Environment Agency Permitting decisions

We have decided to refuse the permit application for Foston Pig Unit and Anaerobic Digestion Plant applied for by Midland Pig Producers Limited.

The application number is EPR/LP3930FA/A001 (the "Application")

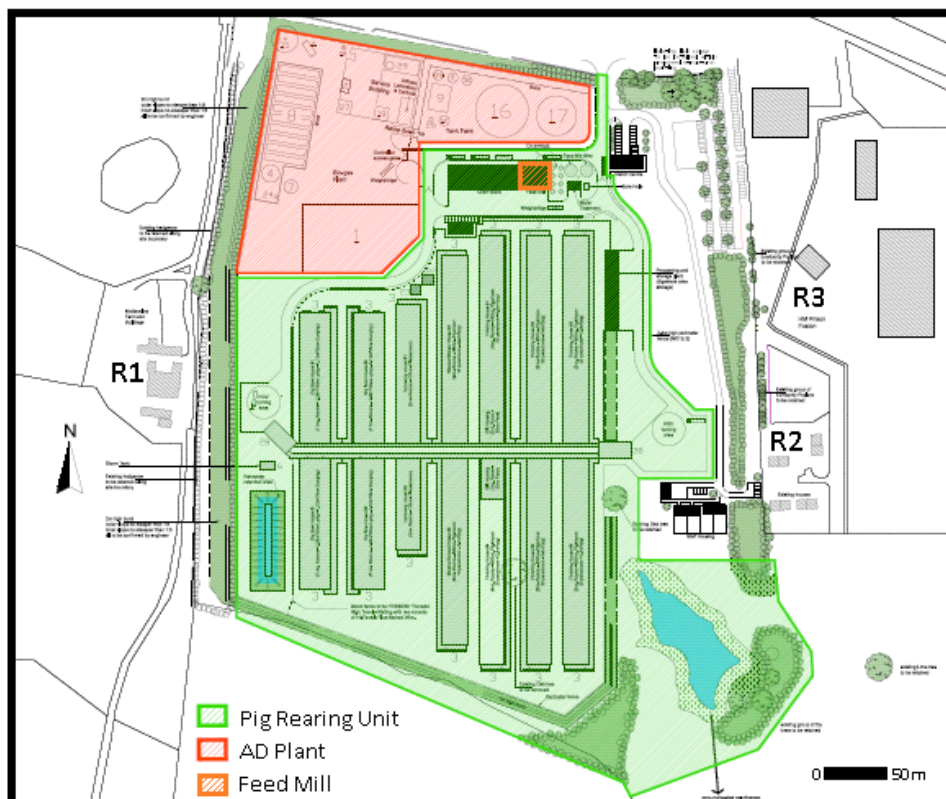
In the case of this application receptors are located very close to the Installation. The following plan shows the location of the closest receptors (R1, R2 and R3) in relation to the proposed Installation.

The above plan shows the close proximity of receptors. There are also a number of other receptors within 400m of the installation boundary that are not shown above that have the potential to be adversely impacted on, if odour is not controlled on site.
